# ES\_LPC83x

Errata sheet LPC83x

Rev. 1.2 — 13 April 2022

**Fig 1. Incorrect setting of RXIDLE during UART receive**

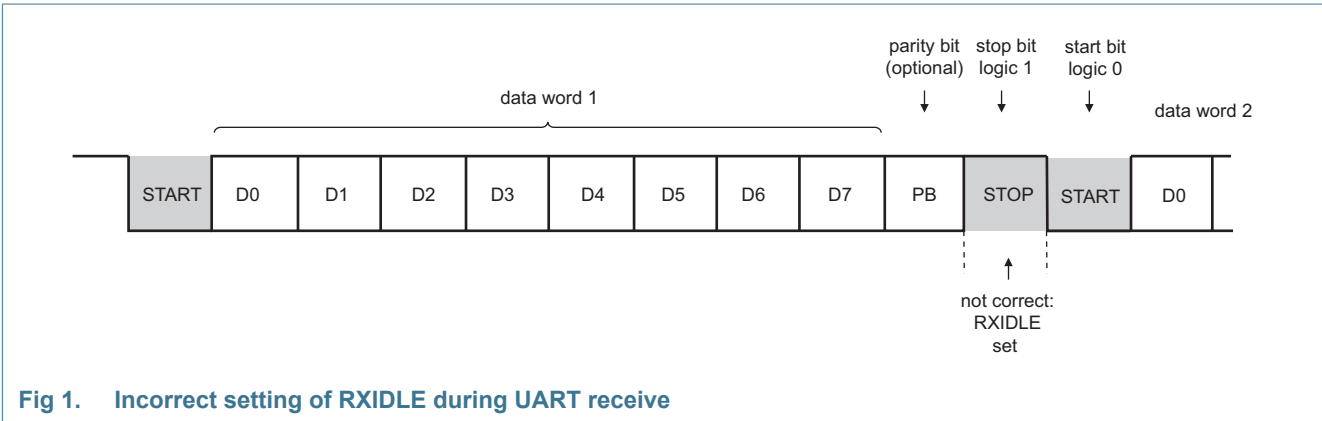
The RXIDLE bit is incorrectly set for a fraction of the clock cycle between the reception of the last data bit and the reception of the start bit of the next word, that is while the stop bit is received. RXIDLE is cleared at the beginning of the start bit.

When writing code that checks for the setting of any of the status bits RXIDLE, TXIDLE, TXDISSTAT, check the value of the status bit in the STAT register:

- If status bit = 1, add a delay of one UART bit time (if STOPLEN = 0, one stop bit) or two bit times (if STOPLEN = 1, two stop bits) and check the value of the status bit again:
  - If status bit = 1, the receiver is idle.
  - If status bit = 0, the receiver is receiving data.
  - If the status bit = 0, the receiver is receiving data.

**Fig 2. Incorrect setting of TXIDLE and TXDISSTAT during UART transmit**

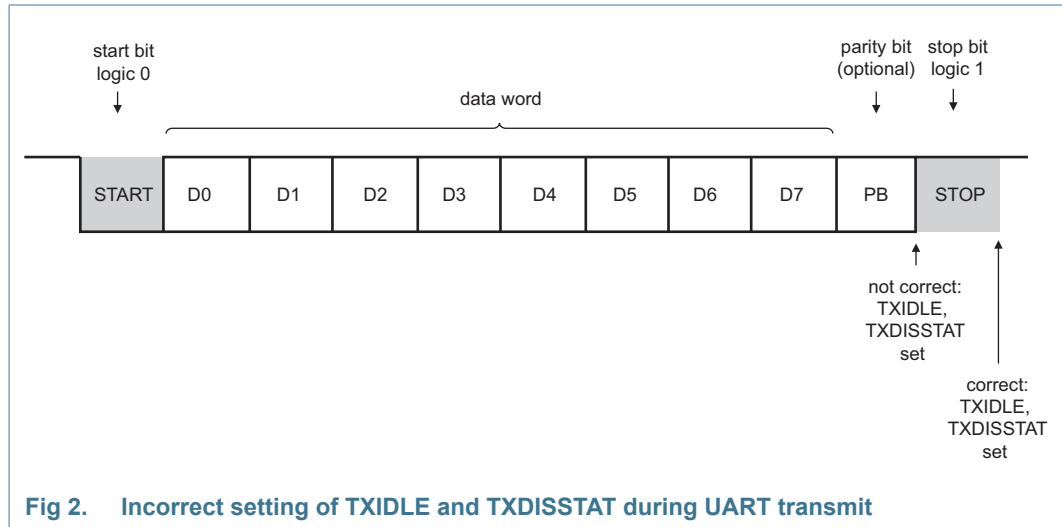
Both, TXIDLE and TXDISSTAT are set incorrectly between the last data bit and the stop bit while the transfer is still ongoing.
